PCN#20181214004.1 New Tray for Select Devices Final Change Notification

Date: December 18, 2018 **To:** PREMIER FARNELL PCN

Texas Instruments is pleased to announce the qualification of a new tray for the devices listed below. A comparison summary of the differences as follows:

Engineering Validation Results – Fit analysis

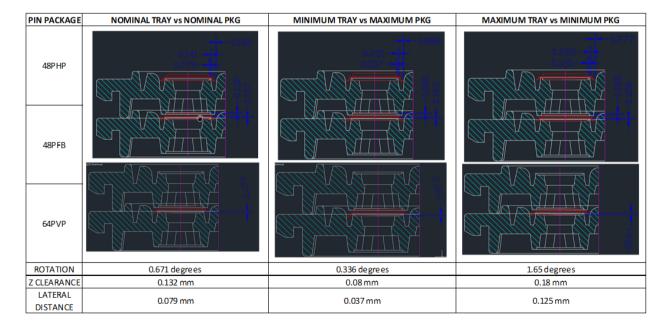
Rotation is less than 10 degrees
